**TOWN OF MOUNTAIN VILLAGE
REGULAR DESIGN REVIEW BOARD MEETING
THURSDAY AUGUST 1, 2019 10:00 AM
2nd FLOOR CONFERENCE ROOM, MOUNTAIN VILLAGE TOWN HALL
455 MOUNTAIN VILLAGE BLVD, MOUNTAIN VILLAGE, COLORADO
REVISED AGENDA**

3.	10:05	45	Miller	Public Hearing Quasi-Judicial	Consideration of a Design Review: Initial Architecture and Site Review Application for a new single-family residence on Lot 640BR 1, Timberview (continued from July 11, 2019)

4.	10:50	45	Miller	Public Hearing Quasi-Judicial	Consideration of a Design Review: Initial Architecture and Site Review Application for a new single-family residence on Lot 640BR-4, Timberview

CONSTRUCTION STAGING PLAN
SCALE: 1" = 5'

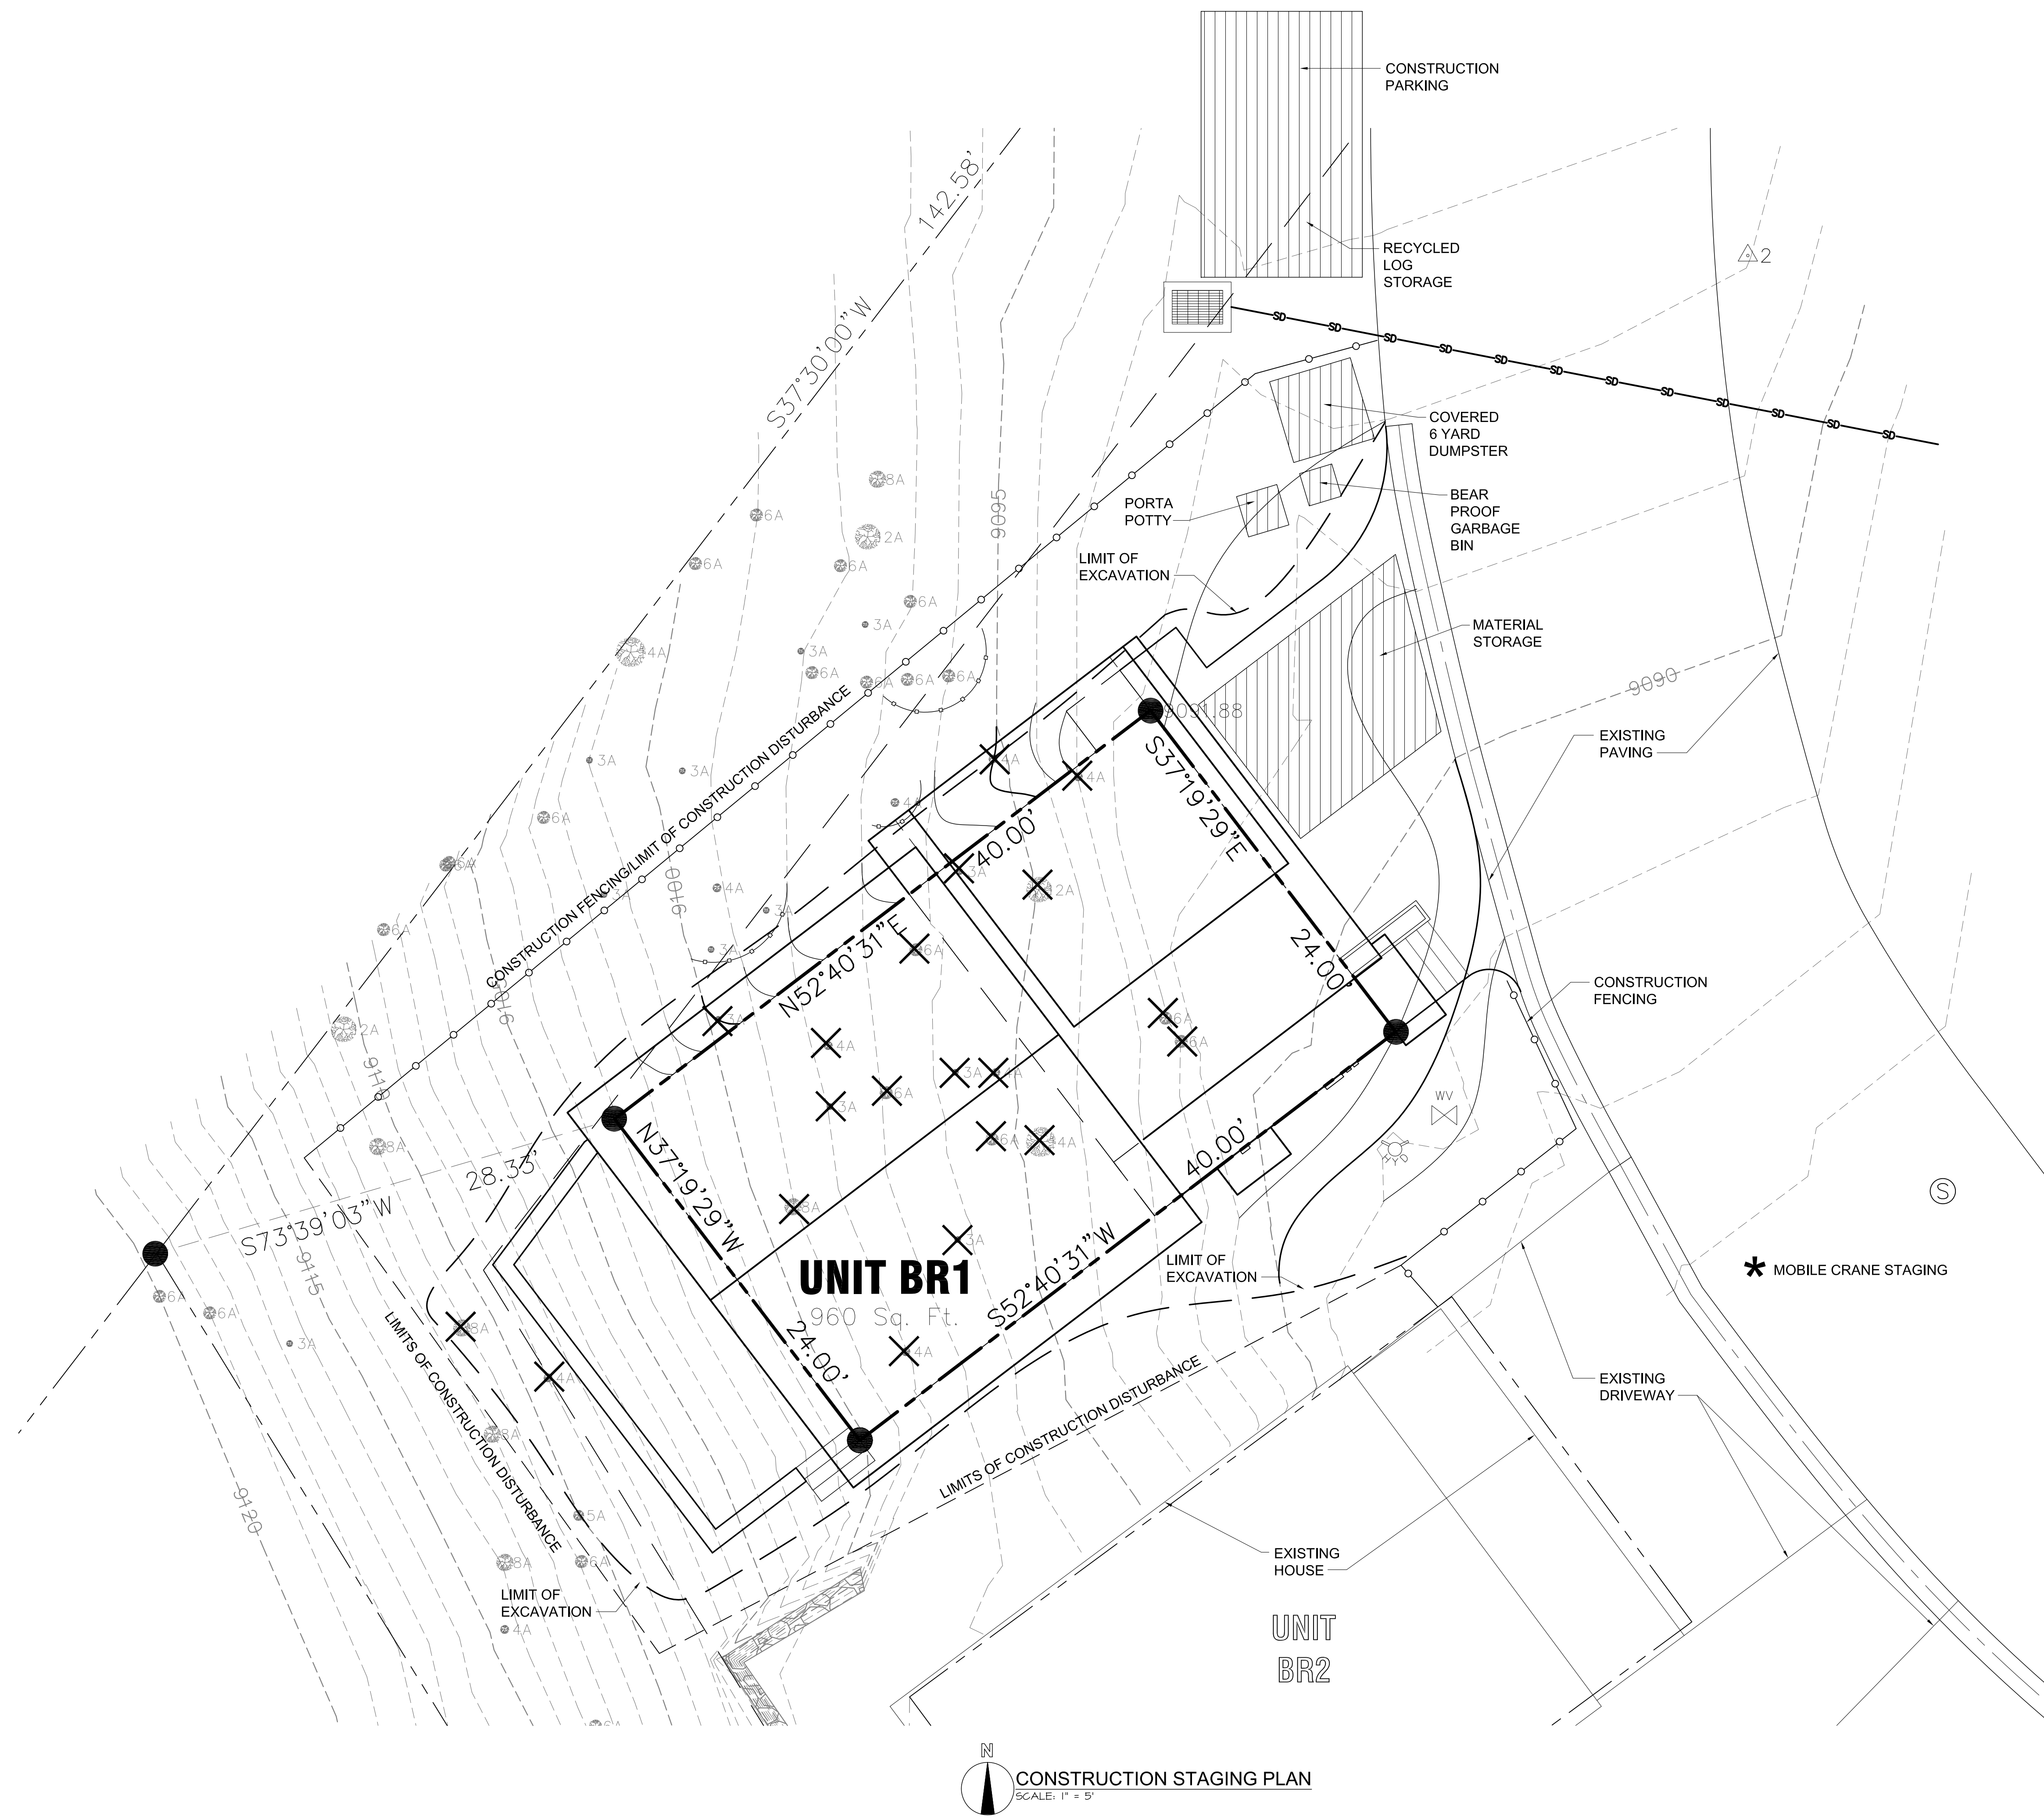
Staff: The applicant has submitted a CMP as part of this application. Staff generally is supportive of the plan with the exception of the area identified as construction parking which is located within the General Easement of Lot 640BR. If the DRB determines this parking to be appropriate, staff recommends conditioning that the disturbed area be revegetated and brought back to its original pre-disturbed condition. Staff prefers to require the parking to occur in an area not within the general easement. Due to the project's proximity to existing homes and common community elements, it is important to address construction mitigation prior to final review. This shall include parking, material stockpiling, areas of disturbance, and other requirements of the CDC.

- 3) The applicant shall be required to update the Construction Mitigation Plan to better detail construction parking, and material storage areas - in conformance with the requirements of the CDC.
